Final Work Plan  
**Pre-Design Investigation**  
Operable Unit 2C, Landfill Sites 3 and 5  
Former Marine Corps Air Station  
El Toro, California

Subject: INTERIM FINAL WORK PLAN AND HEALTH AND SAFETY PLAN, PRE-  
DESIGN INVESTIGATION, OPERABLE UNIT 2C, LANDFILL SITES 3 AND 5,  
FORMER MARINE CORPS AIR STATION (MCAS), EL TORO, CALIFORNIA

This work plan incorporates comments received on the *draft Work Plan* that was prepared by Foster Wheeler Environmental Corporation (FWEC) (FWEC 2000). A response to comments was prepared and submitted to the reviewers and is included in Appendix B.

Pre-Design Investigation		Final Work Plan	
<b>Site 5: Previous Sampling Locations</b>			
Remedial Design IRP Site 3 and Site 5			
Date: 02-02	Former MCAS El Toro		Figure
Project No. 37380	<b>EARTH TECH</b> <small>A tyco INTERNATIONAL LTD. COMPANY</small>		2-4

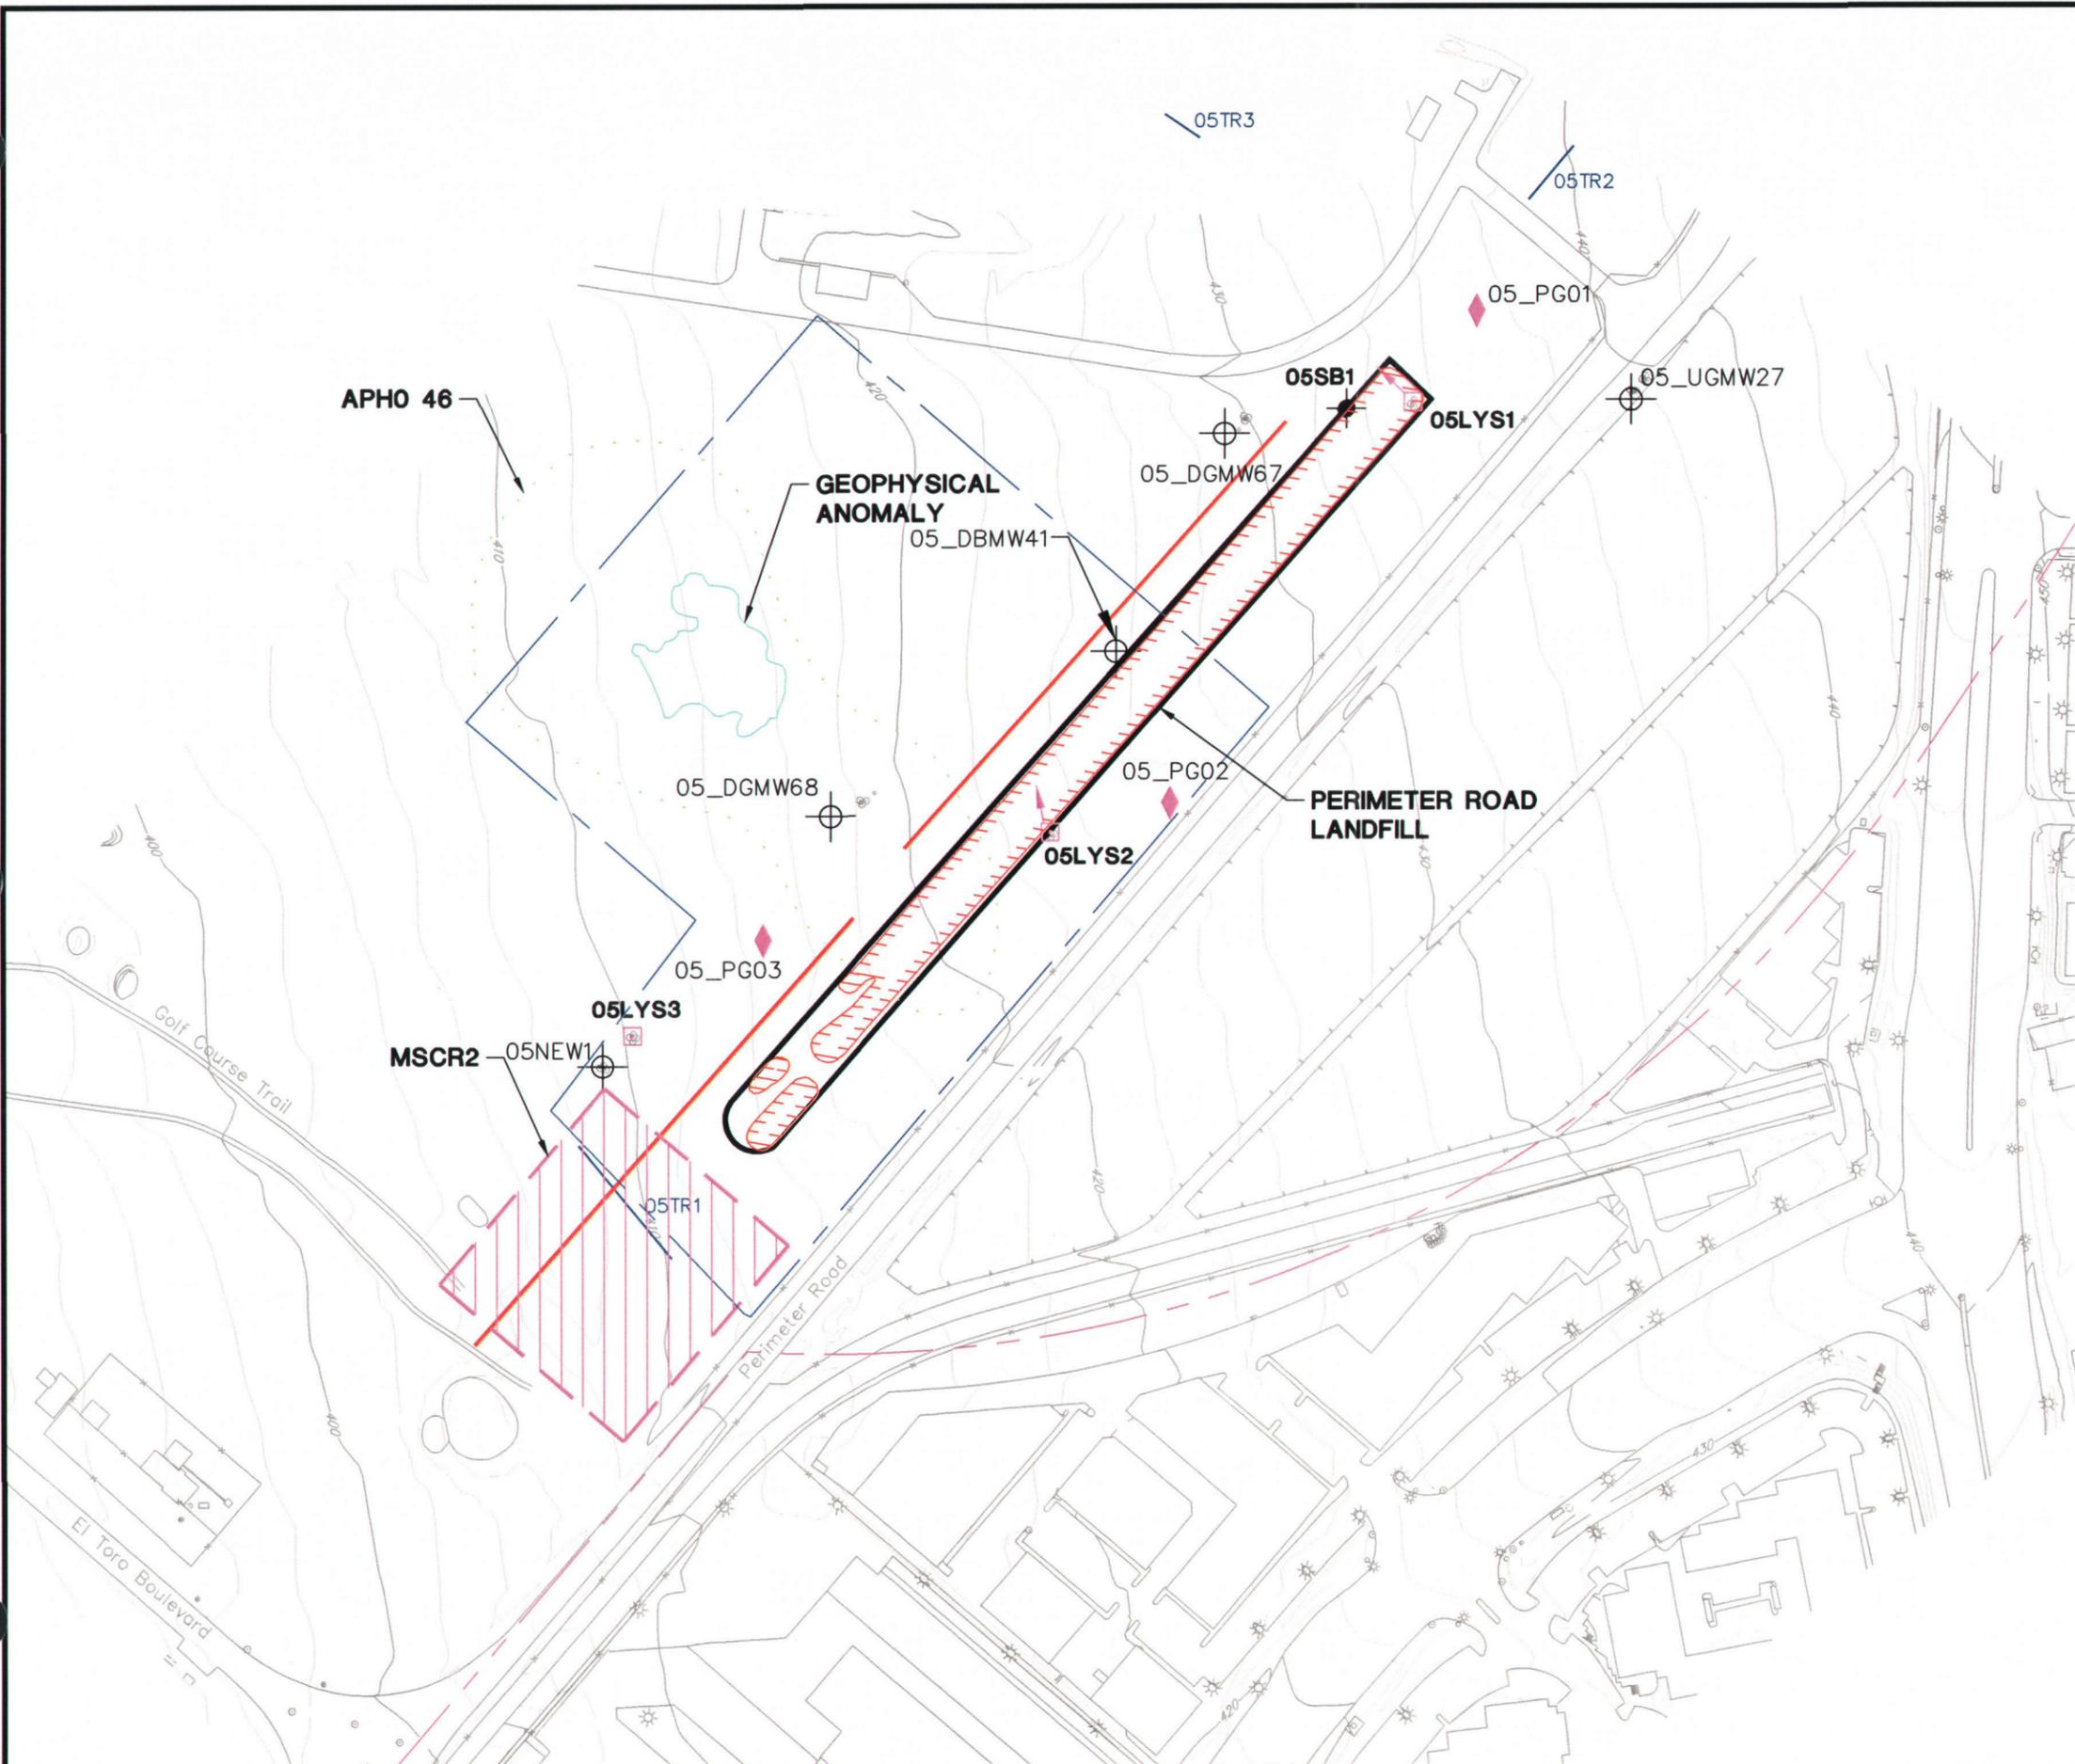
Comment No.	Section/ Page No.	Comment	Response
6.	3.1.1.1	Section 3.1.1.1 contains a description of a feature interpreted in the geophysical investigations for Site 5 as a buried utility. However, this feature is not shown on Figure 5, the Site 5 site plan. Please revise Figure 5 to include the feature interpreted as a buried utility.	Figures 2-2, 2-4, and 3-2 (of the Final Work Plan) have been revised to include the buried utility (interpreted). In addition, utility plans have been reviewed and used to confirm the presence of the buried utility.

Pre-Design Investigation		Final Work Plan	
<b>Site 3: Proposed Trench Locations</b>			
Remedial Design IRP Site 3 and Site 5			
Date:	02-02	Former MCAS El Toro	
Project No.	37380		Figure 3-1
<small>A tyco INTERNATIONAL LTD. COMPANY</small>

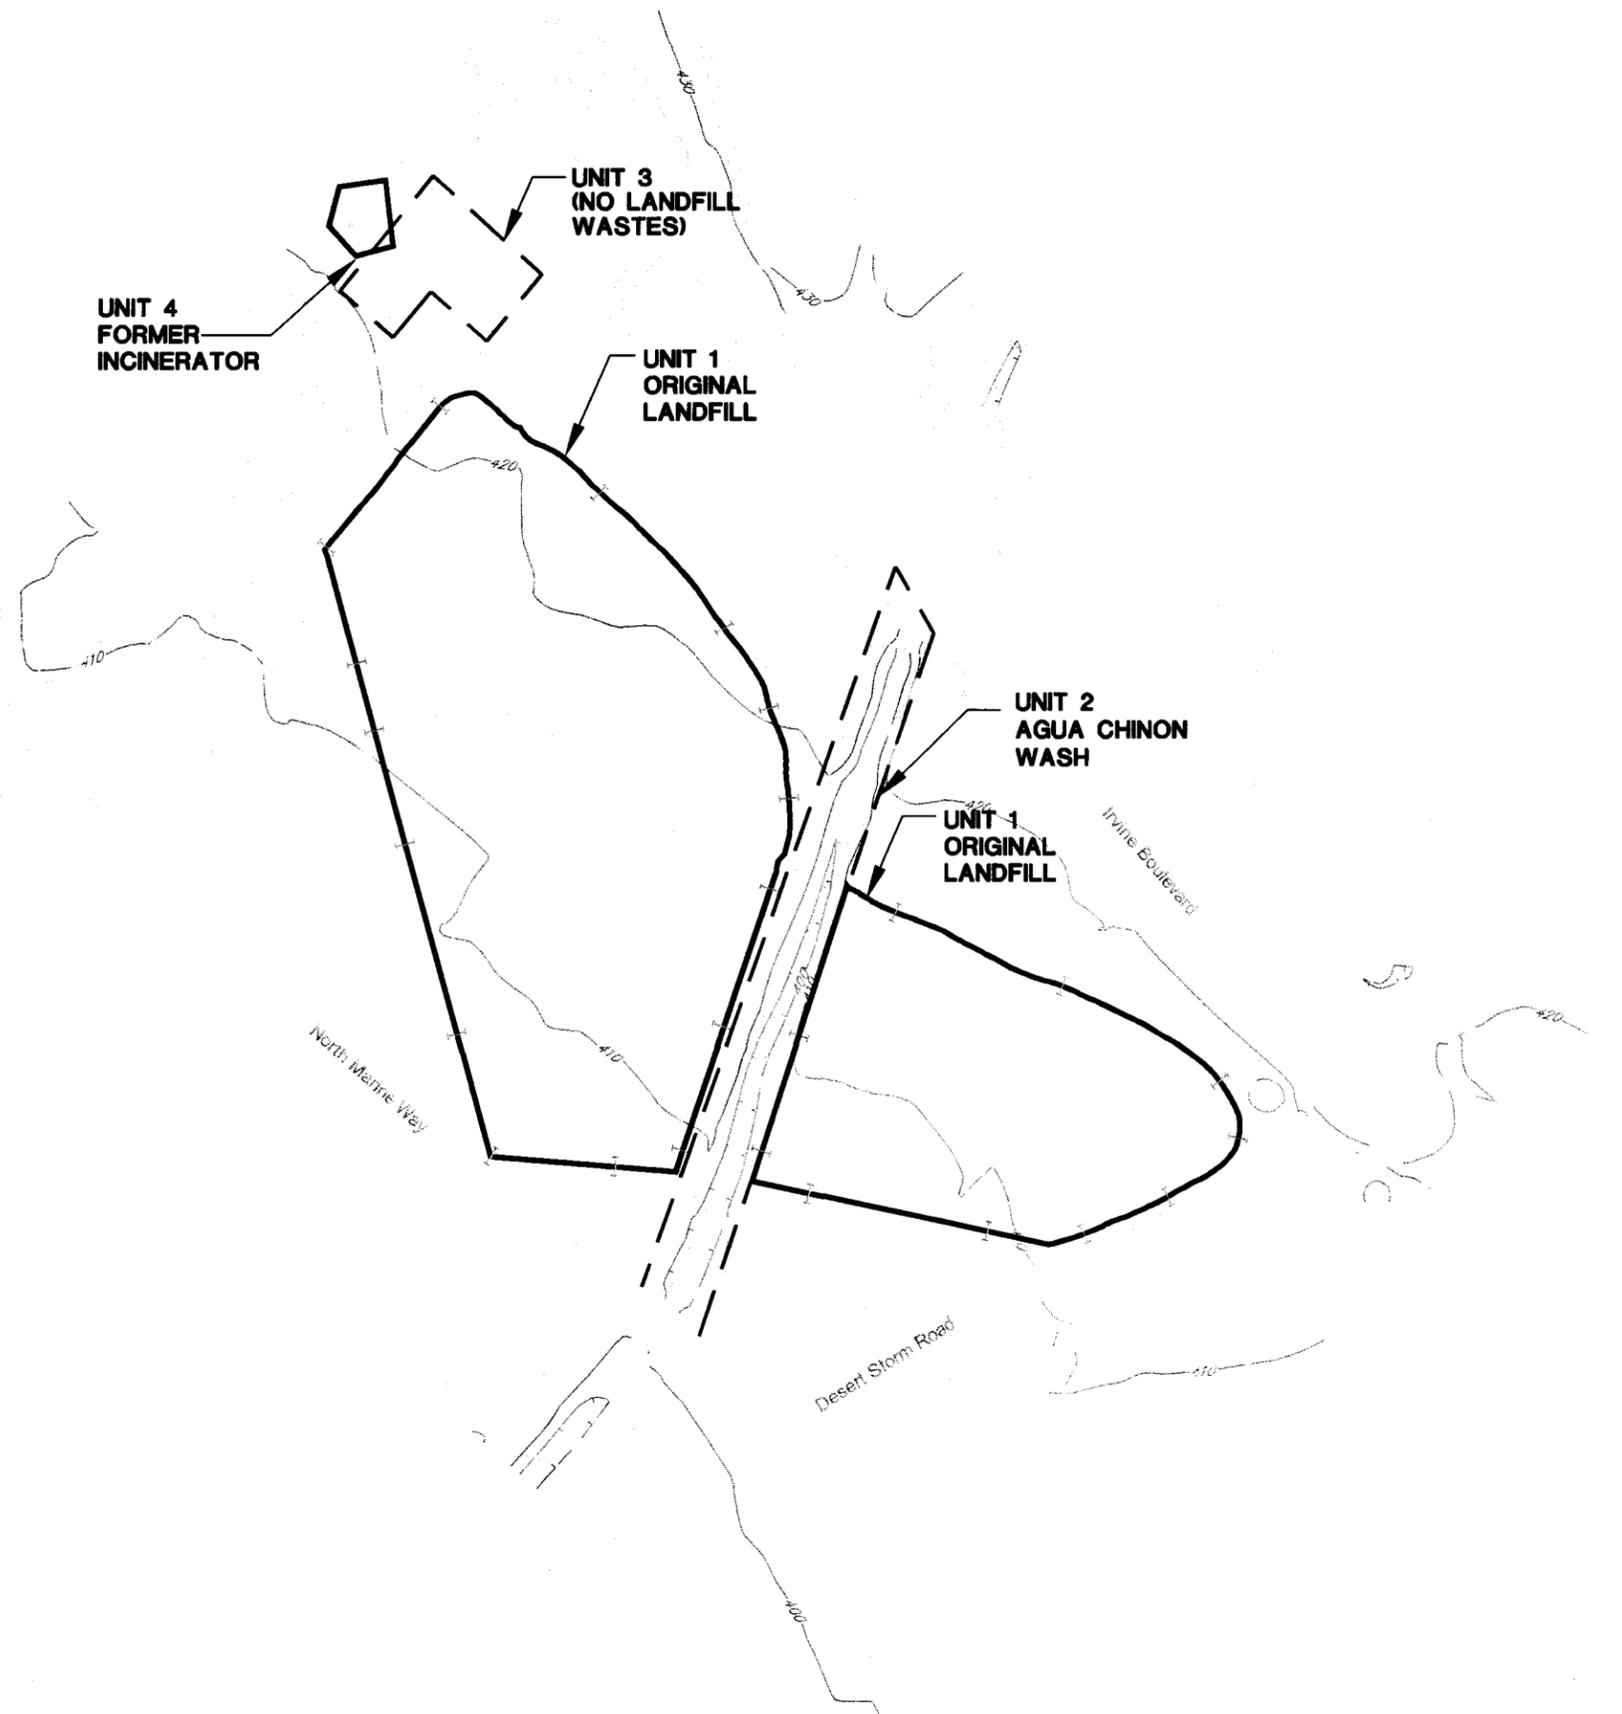
5.	3.1.1.1	Section 3.1.1.1 describes anomalies determined by the geophysical investigations for Site 3. No anomalies are shown on Figure 4. Please revise Figure 4 to show all anomalies found.	Anomalies identified during the RI that may intersect the landfill boundary at Site 3 has been added to Figure 2-3 (of the Final Work Plan) and evaluated, where possible, to confirm the lateral and vertical extent of waste/fill material.

27.		On Figure 4, the trench locations proposed for Site 3 are shown. Absent are any evaluations of either the banks of Aqua Chinon Wash (both east and west banks) or the area around Building 796 (reported in Section 3.2 as the building for which waste was observed in the foundation excavation). Note that the Aqua Chinon Wash banks could be composed of edge Berms used for waste perimeter control, similar to situations found at many other solid waste landfills of the mid-1900s. Please revise the project approach and the figure to accommodate investigation of both banks and the building perimeter.	<p>Trenches have been proposed to be excavated at both banks of the Aqua Chinon Wash, and adjacent to Building 796.</p> <p>Trenches will be advanced in the vicinity of the building(s) where possible, with consideration for foundations, utilities, or other limiting factors. In addition, if the building(s) are within the limits of the landfill boundary these data will be taken into consideration during the preparation of the remedial design.</p>
